2.5.4 Information Systems Important to Safety

2.5.4.1 Design Description

Figure 2.5.4-1 Configuration of the PSMS and PCMS for Information Systems Important to Safety

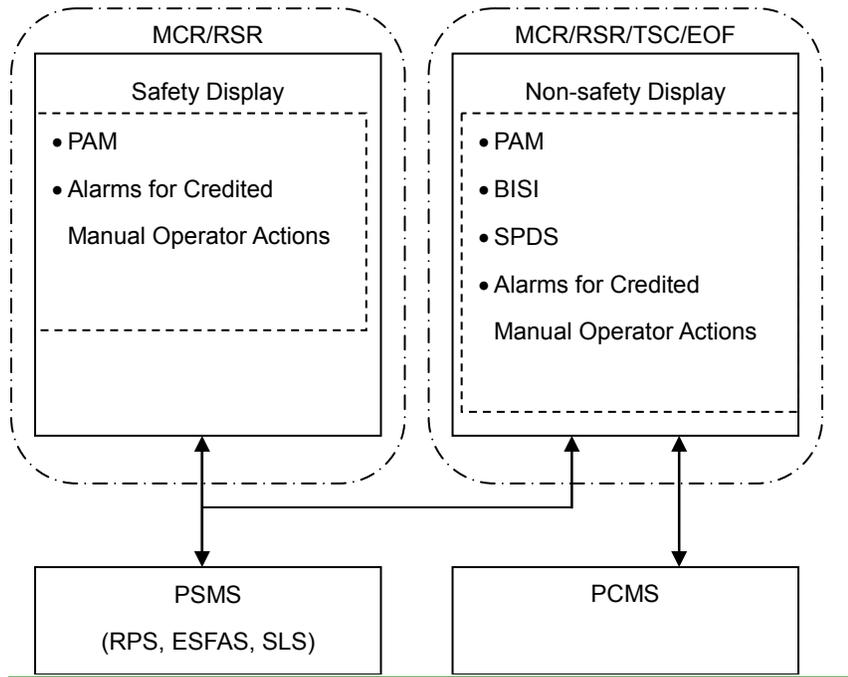
~~Figure 2.5.4-1 shows the configuration of the PSMS and PCMS for implementation of the information systems important to safety. The PSMS redundancy, independence, testability, qualification, quality and life cycle descriptions of Subsection 2.5.1 are also applicable to the information systems important to safety within the PSMS. The PCMS redundancy, qualification and quality descriptions applicable to the information systems important to safety are as described in Subsection 2.5.5.~~

1. PAM variables as identified in Table 2.5.4-1, BISI, SPDS information, and plant alarms for credited manual actions as identified in Table 2.5.4-3, for information systems important to safety, are provided on safety and non-safety HSI equipment at the MCR, RSR, TSC, and EOF, as shown in Figure 2.5.4-1.

Note: Controls for credited manual operator actions are available in the MCR.
